Re: Updated Plans for Schoolhouse Apartments Rockland located at 6 Delprete Avenue, Rockland, MA.

RE: Schoolhouse Apartments – Chapter 40B Comprehensive Permit – Response to Amory Engineers, P.C. Peer Review

Subject: Schoolhouse Apartments Rockland

C-2

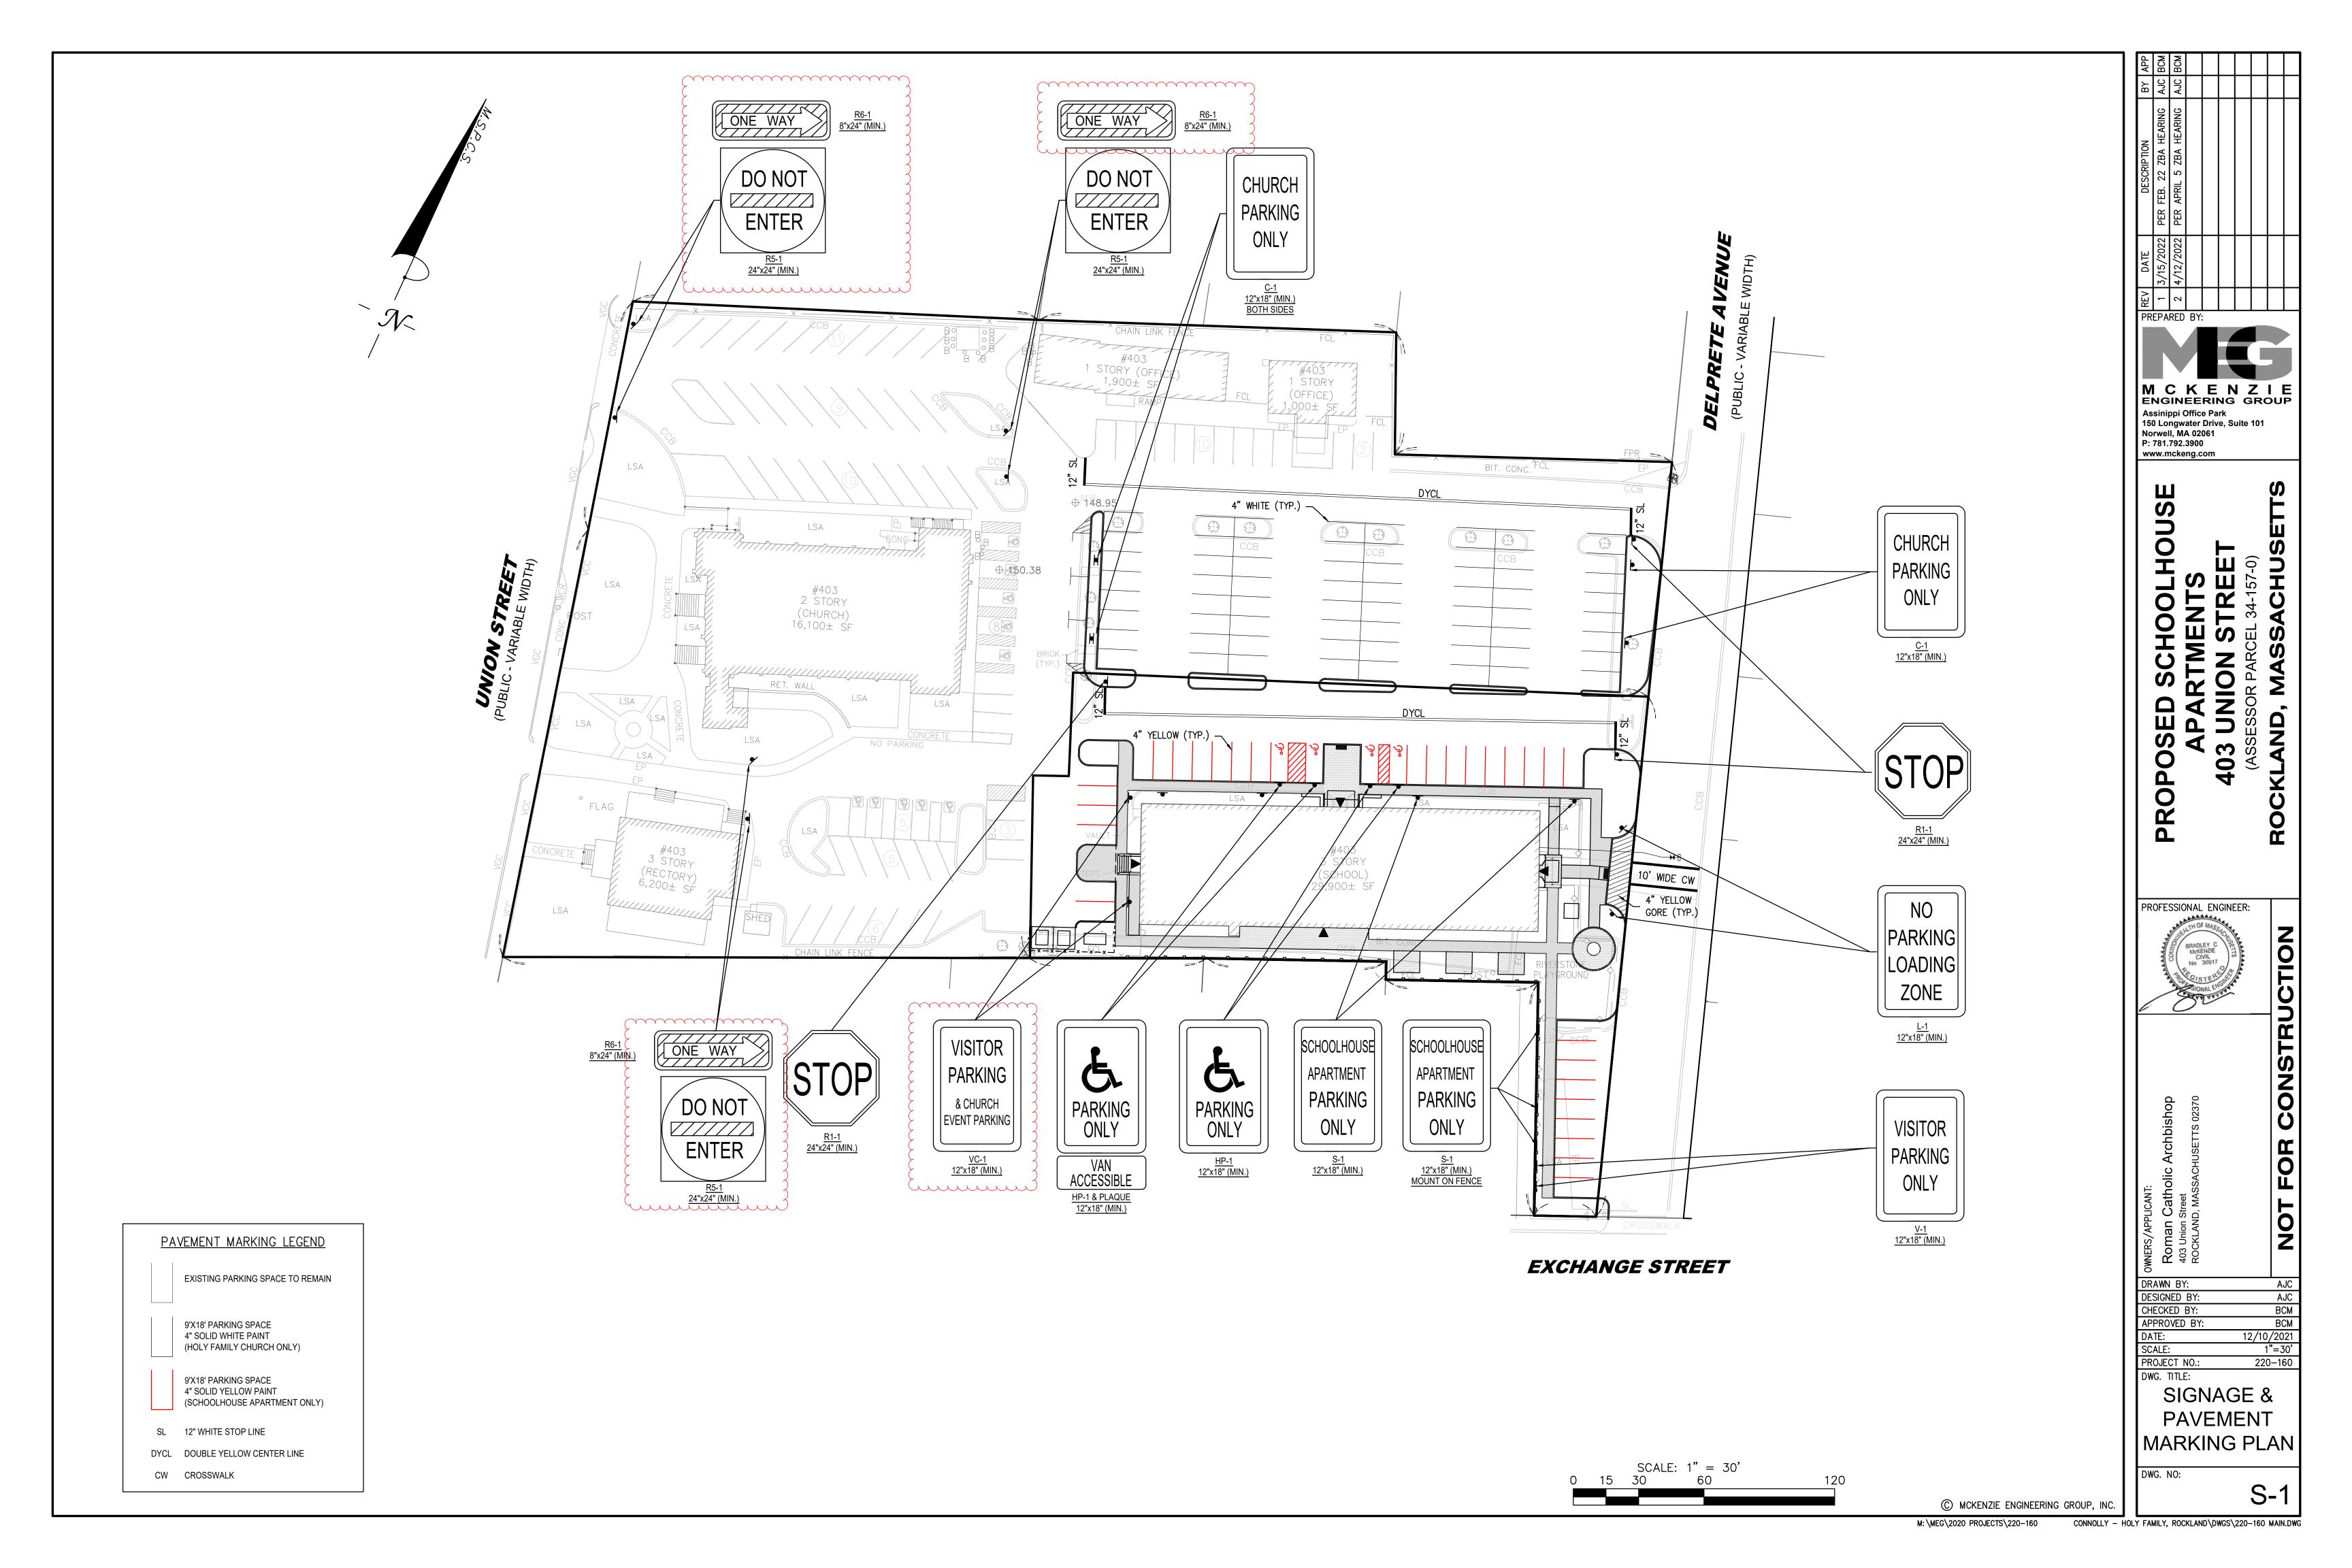
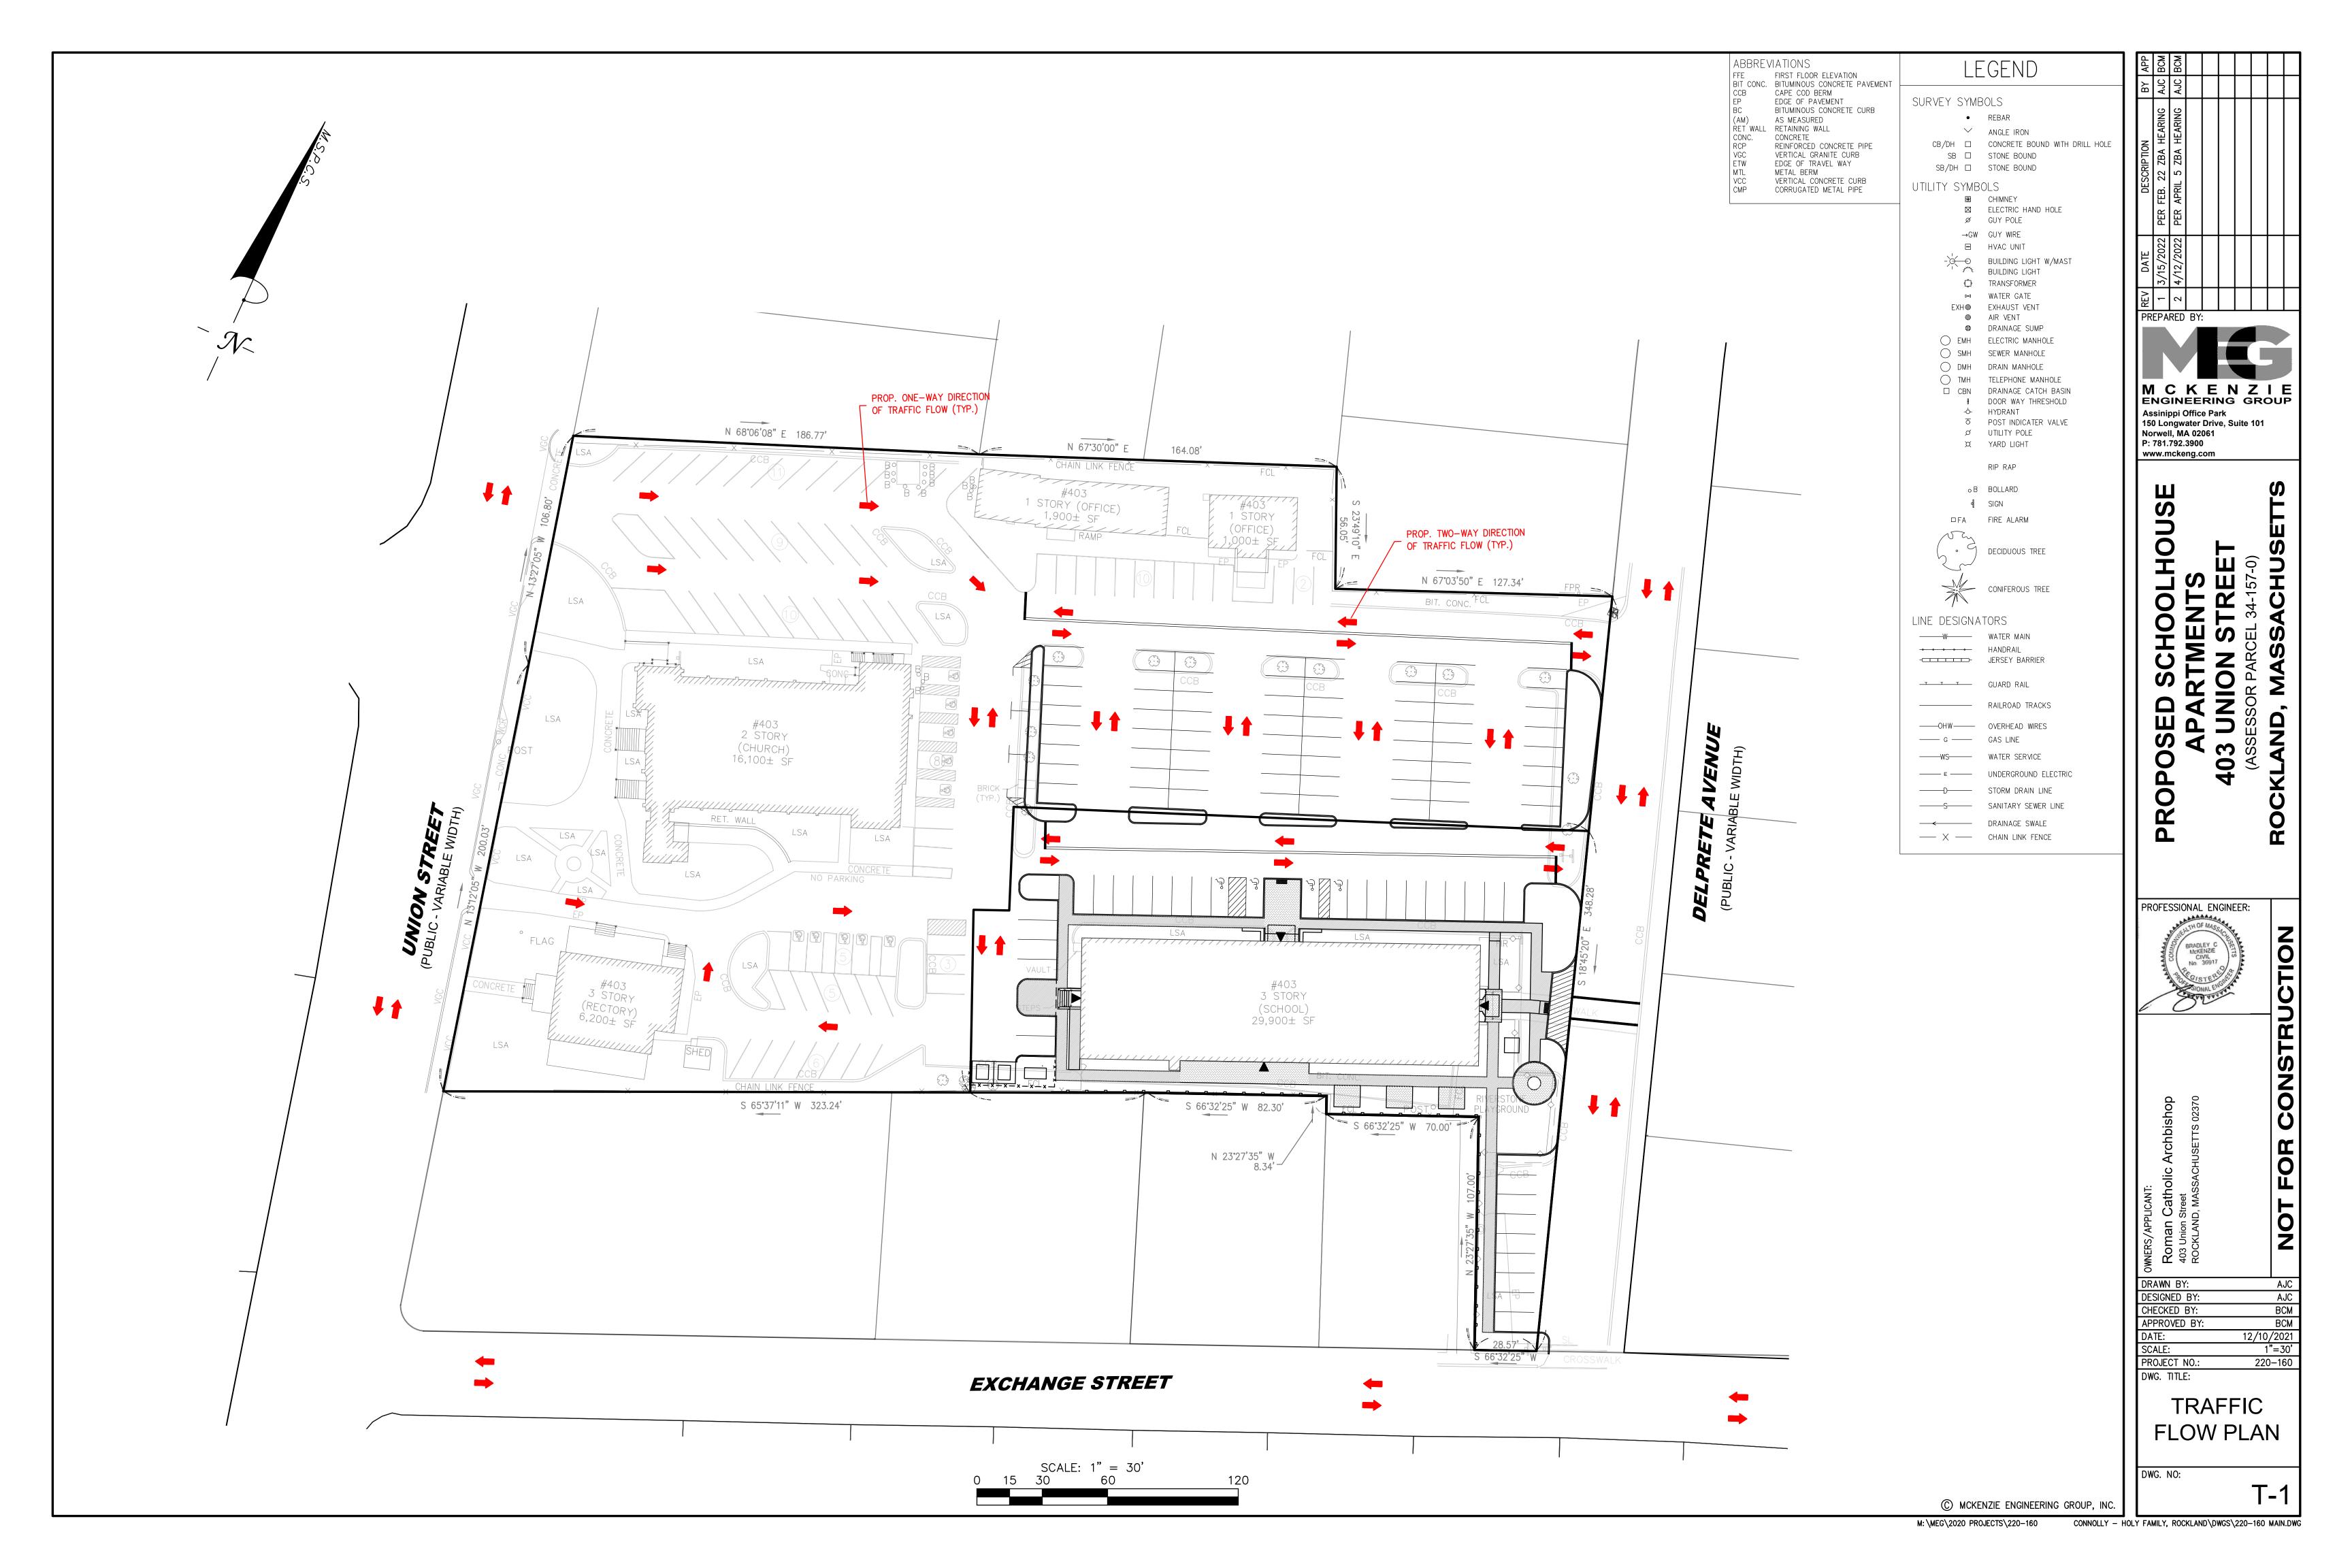
- 1. New/replaced catch basins should be equipped with four foot sumps and gas-trap hoods.
 - Language has been added to the plans that new/replace catch basins shall be equipped with four foot sumps and gas-trap hoods. See Grading and Utility Plan, Sheet C-2, and Construction Detail Sheet, CD-1.

- 2. If there are sumps in existing catch basins the existing catch basins should also be equipped with gas-trap hoods wherever possible.
 - Language has been added to the plans that existing catch basins to be retained shall have gas-trap hoods installed. Existing infrastructure is also proposed to have sediment removed and pipes cleaned. See Grading & Utility Plan, Sheet C-2.

- 3. We note that when the existing lot is subdivided, easements will be required for shared stormwater infrastructure, sewer infrastructure, parking and access/egress.

- Easement will be provided for as required. A Reciprocal Easement document has been prepared as part of the lot creation which will legally allow access to both parcels and will be recorded with the lot. In addition, a 20' sewer easement is proposed across Lot A to provide access rights to the sewer infrastructure. See ANR Plan, Sheet ANR-1, and Grading and Utility Plan, Sheet C-2.
